DEVELOPMENT REVIEW COMMITTEE (DRC) COMMENT REPORT

PROJECT NAME: Right of Way Vacation – Coconut Drive

CASE NUMBER: UDP-V21002

REQUEST: Right-of-Way Vacation: 50-foot wide by 102-foot long
Portion of Coconut Drive

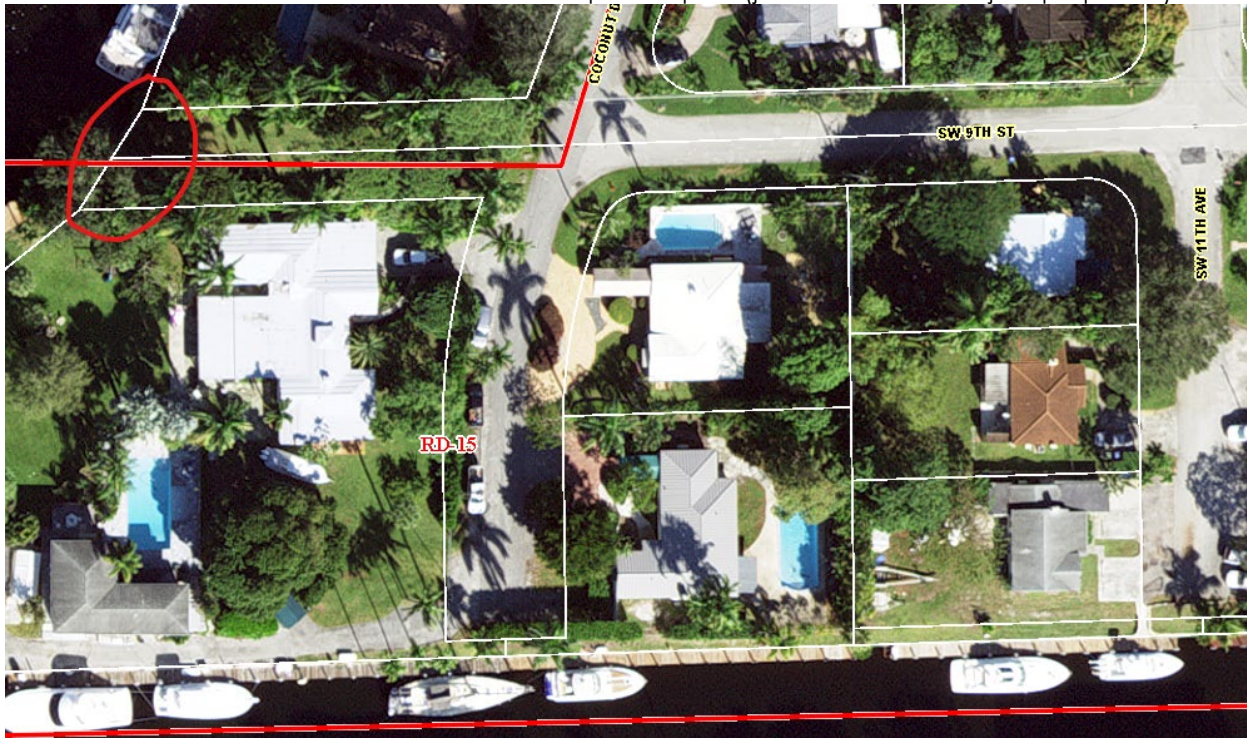
- 5) Provide updated sketch and legal documents showing cross-access easements for properties located at 900 and 910 Coconut Drive, to address access to them from SW 9th Street if the ROW is vacated.

RESPONSE: As discussed above under Engineering Comments – the reverted parcels will be owned by a Florida LLC for the purpose of providing all necessary access.

SW 9th Street dead ends into the river and has a pocket park (just north of the subject properties):

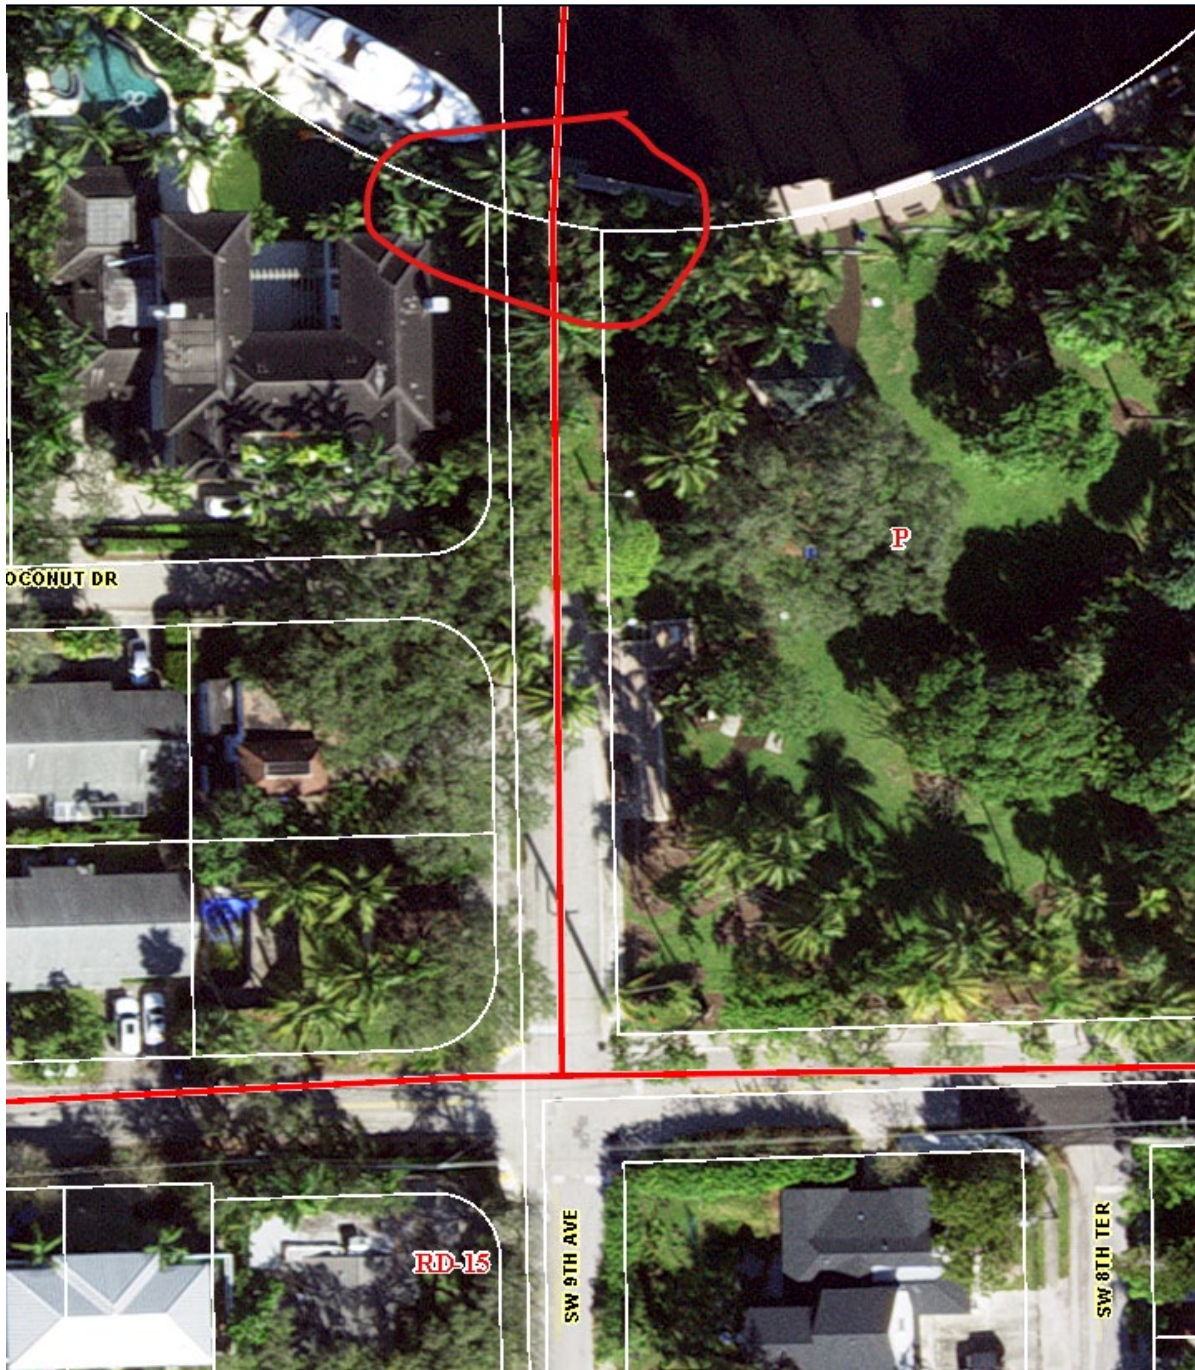
6) The City's adopted Park and Recreation Master Plan indicated the need to maintain access and views to waterways throughout the City. Provide locations of other water access points in the surrounding area.

RESPONSE: Note, that there is no access or views on the end of Coconut Dive as it dead ends into private property.

There are multiple water access points in the Tarpon River Neighborhood. For example:
